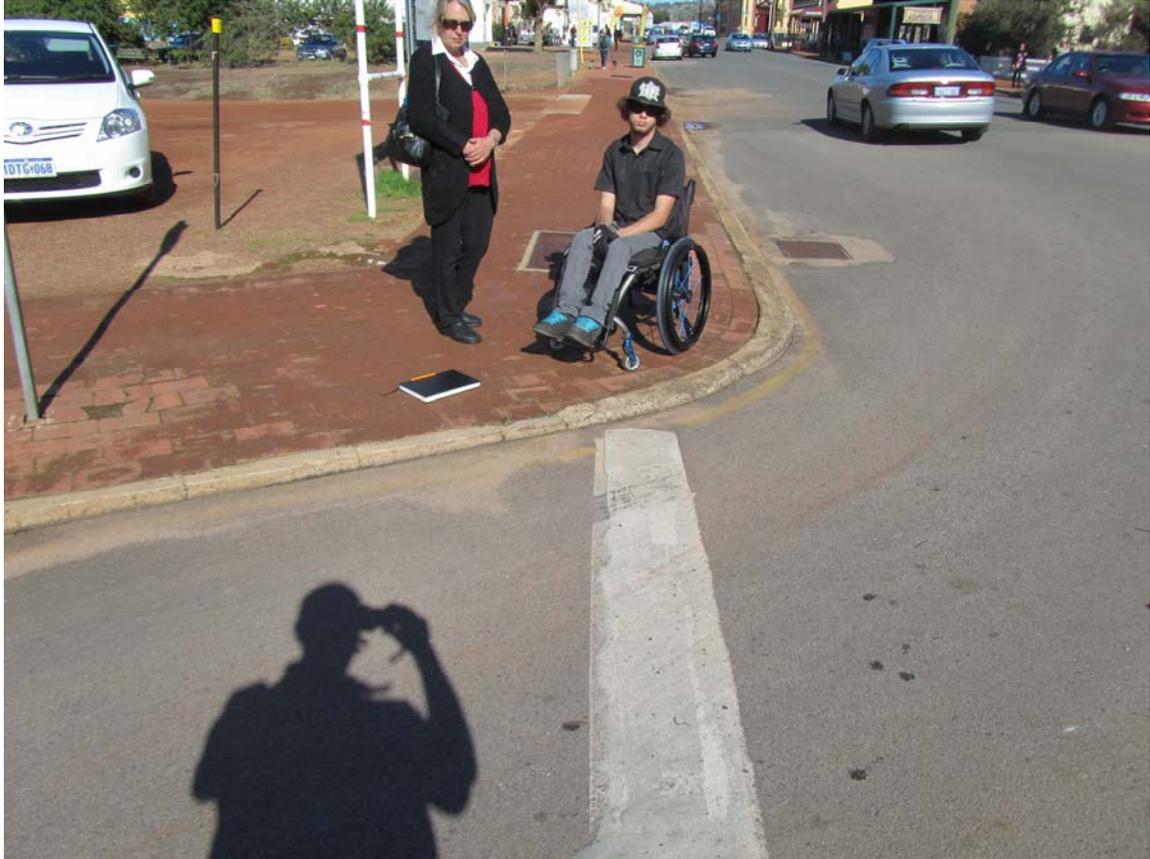
This is where the ramp needs to be situated so a person crossing the road can see oncoming traffic.

This is where the ramp should be located as to line up with the correct position of the ramp outside the Town Hall.
